QUESTIONS AND ANSWERS RELATED TO THIS PROJECT

DESIGN / BUILD SERVICES FOR MARSH ROAD WATER PUMP STATION TOWN OF HUDSON, NEW HAMPSHIRE

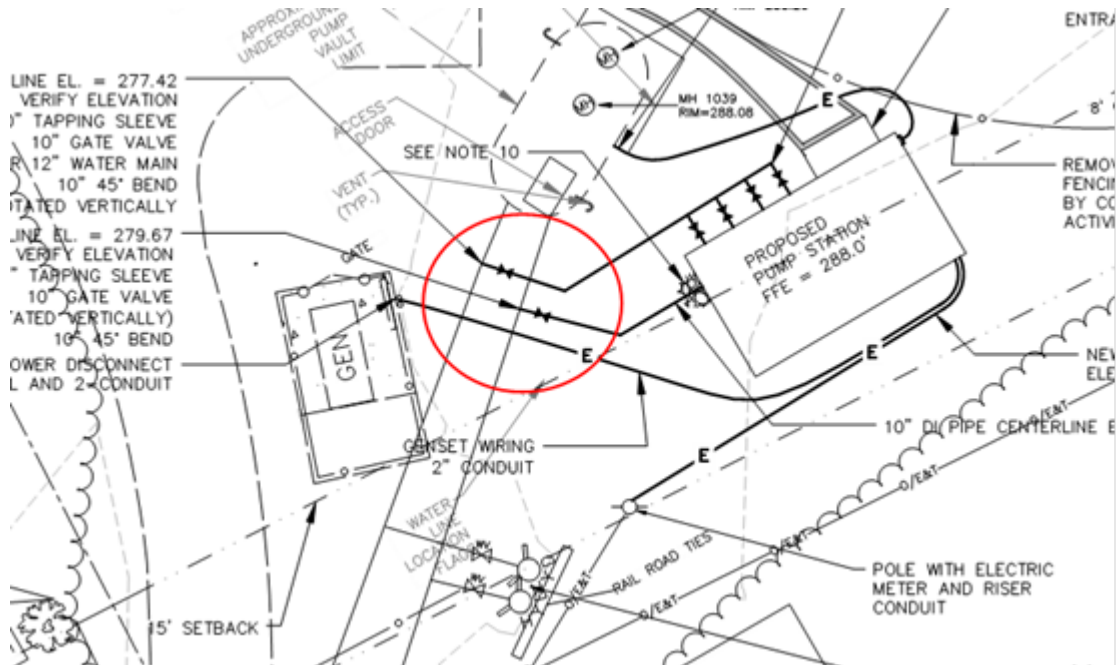
Question 2: Please elaborate on the bullet, “The proposed work will include all water piping installation within 5 feet of the building.” For example, are Tap & Sleeves, Piping, and valve headers included in the scope of this contract. See image below from Drawing C001:

Answer 2: Water pipe work will only include only the pipe within 5 feet from the building foundation. No tap and sleeve will be required for this phase of the project.
